UNITED STATES ENVIRONMENTAL PROTECTION AGENCY  
REGION 5  
EMERGENCY RESPONSE BRANCH  
9311 GROH ROAD, ROOM 216  
GROSSE ILE, MI 48138-1697

**RE: West Vermont Street Drinking Water Contamination Site (B5UJ)  
Speedway, Marion County, Indiana**

The U.S. Environmental Protection Agency completed its review of the *Technical Response to "Technical Memorandum: Analytical and Hydrogeological Evaluation, West Vermont Street Site, Speedway, Marion County, Indiana," Prepared for USEPA by Weston Solutions, Inc. (January 30, 2013)*. The *Technical Response* was prepared by R.C. Minning & Associates, Inc. and Mundell & Associates, Inc. on behalf of AIMCO Michigan Meadows Holdings, LLC (AMMH) for the Michigan Plaza Site in Indianapolis, Indiana.

Figure 1  
Eagle Creek Gaging Data  
April 2007 – January 2008

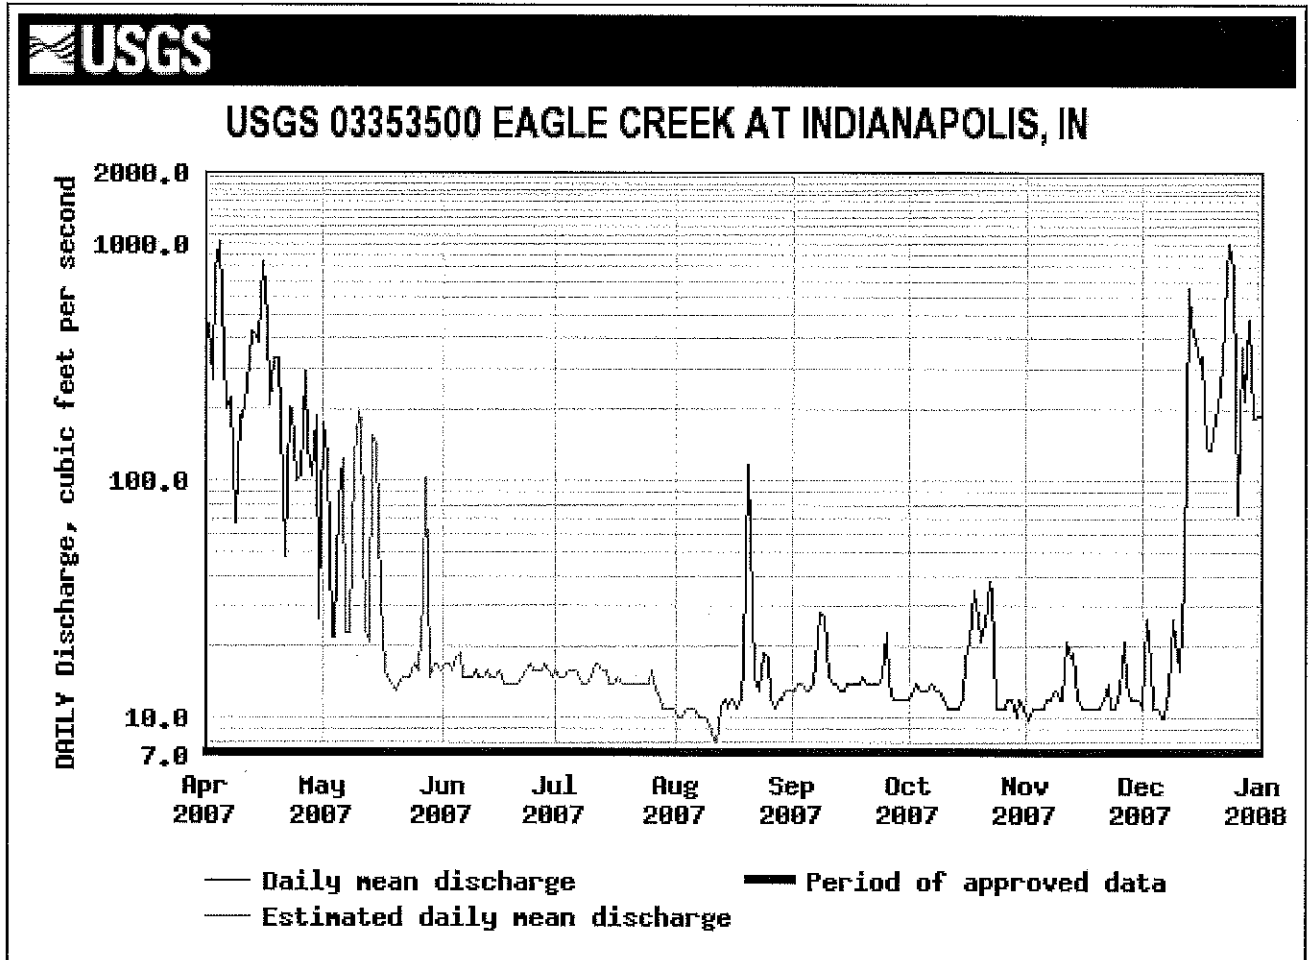
There have been two recent low-flow events on Eagle Creek that would have had significant impacts on groundwater gradient flow directions. One low-flow event occurred May through December of 2007 (Figure 1) and another from July through December 2008 (Figure 2). The effects of these low-flow stream conditions on groundwater flow can be compared to the well-studied state-wide drought in 1988, although the effects of the 2007 event exceeded the 1988 state-wide drought (Figure 3). In 1988, groundwater levels throughout the state were affected by a significant drought, as described in the 1992 U.S. Geological Survey (USGS) report 91-4100, "Description and Effects of 1988 Drought on Ground Water Levels, Streamflow and Reservoir Levels In Indiana." The USGS reported that as groundwater levels declined in 1988, particularly in areas of extensive irrigation, problems of water distribution and use occurred. The USGS report states that "ground-water levels were affected substantially in many areas of the State. Record low-water levels were observed at 12 of the 20 monitoring wells included in [the] report." In another study the Illinois Department of Natural Resources (1994) stated that "streamflow during a drought period originates almost entirely from subsurface storage that seeps into the streambed." In other words, during drought conditions stream flow is derived from groundwater.

During 2007, stream flow gaging stations on Eagle Creek, as well as the monthly mean stream flows, approached record low flows similar to the 1988 calendar year. A similar five-month low-flow event occurred in the Eagle Creek during July through December of 2008. These recent low-flow events, or droughts, in Eagle Creek occurred at approximately the same time as one of the CAP18 injections at Michigan Plaza. The stresses on surface water flow would likely have had a similar effect on groundwater to those described in the 1992 USGS report and would likely have caused a more westerly or southwesterly flow of groundwater from Michigan Plaza toward Eagle Creek.

Figure 4  
Eagle Creek Gaging Data  
1990 to 2012

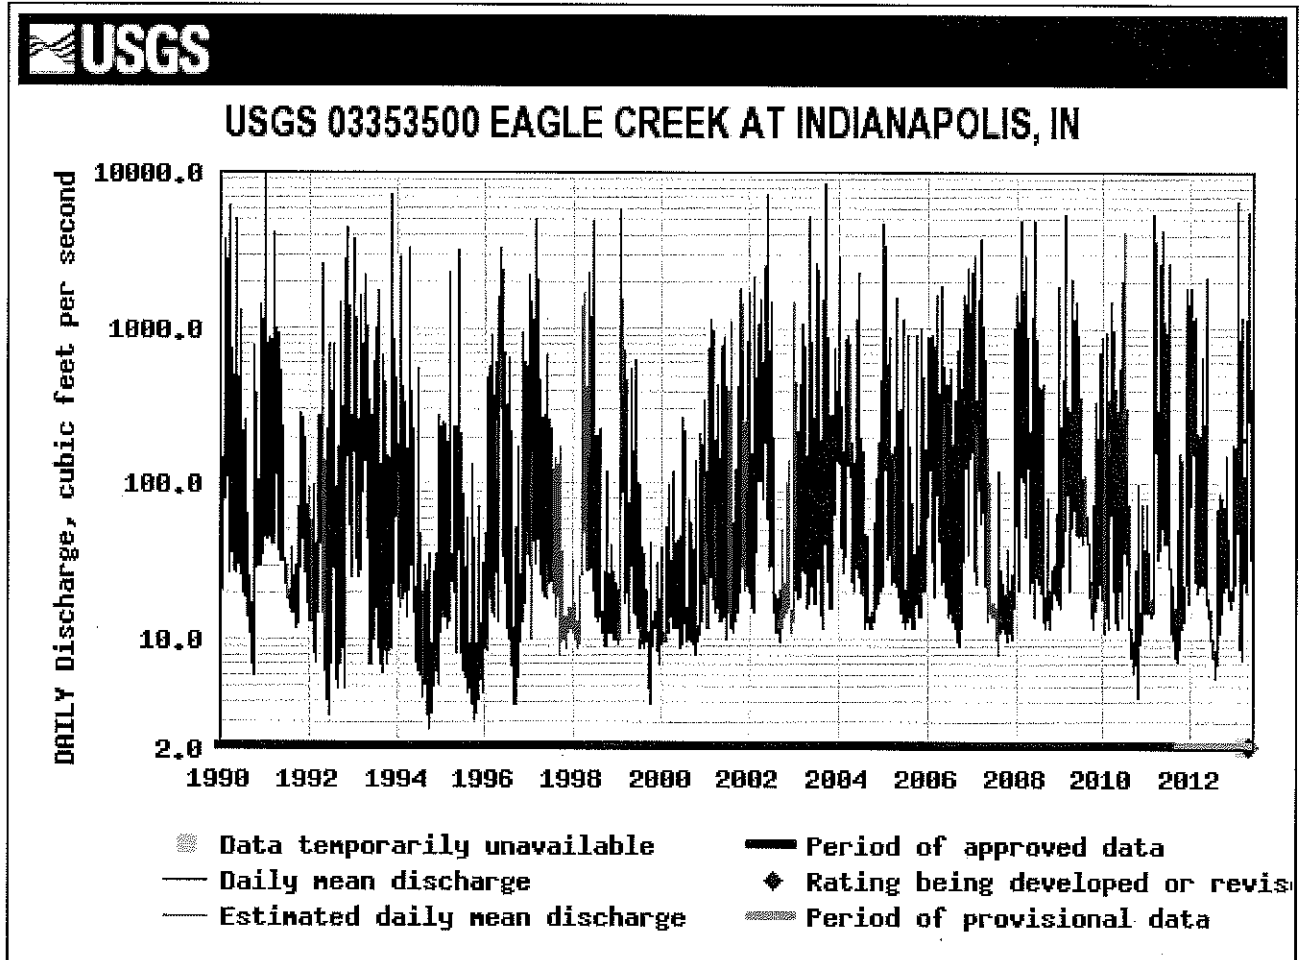
The Eagle Creek long-term (72 year) monthly mean stream flow ranges from a low of 38 cubic feet per second (cfs) (August) to a high of 312 cfs (March) with annual mean of 164 cfs (Figure 4 and Table 1). The large temporal variations between the extended low-flow drought-like conditions (about 11 cfs) in 2007 and 2008 and normal monthly mean flow conditions of these two creeks would affect groundwater flow gradients by creating a gaining stream.

Figure 5a  
Allison Transmission Potentiometric Surface Maps

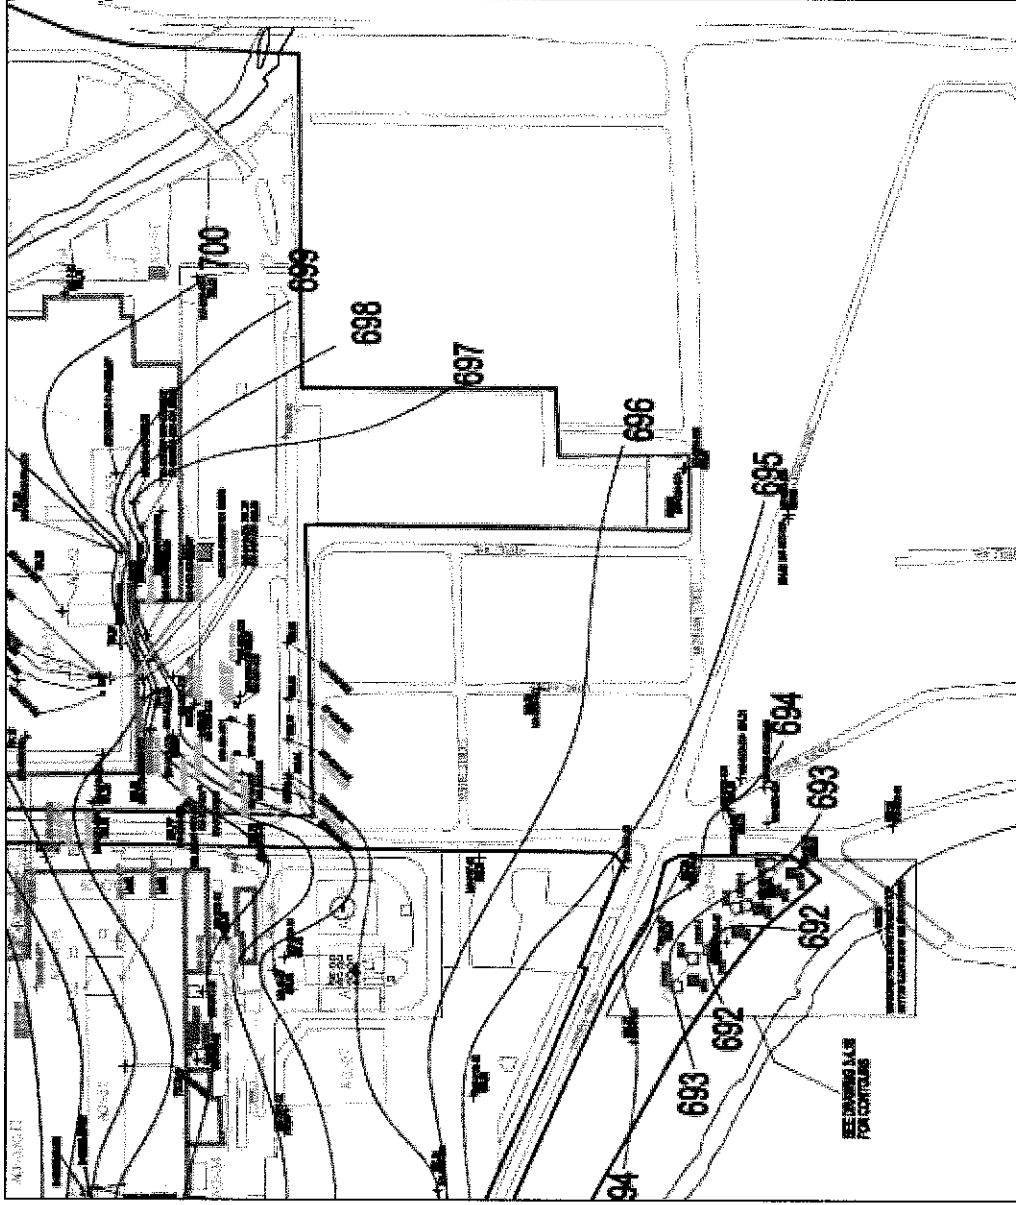
There is a significant capture zone that the Allison Transmission AOI-51 remediation system creates while it is operating. There are a number of Allison Transmission potentiometric maps that show potentiometric lines trending northwest to southeast (Figures 5a and 5b). In the northeast quadrant of the figures, the down-gradient flow direction is to the west-southwest. It appears that the groundwater extraction system may in part cause this southwest flow in groundwater. This west-southwest gradient may extend into the groundwater under Michigan Plaza. However, due to an insufficient number of monitoring wells in this area, one cannot determine how far to the southeast this west-southwest trending groundwater occurs.
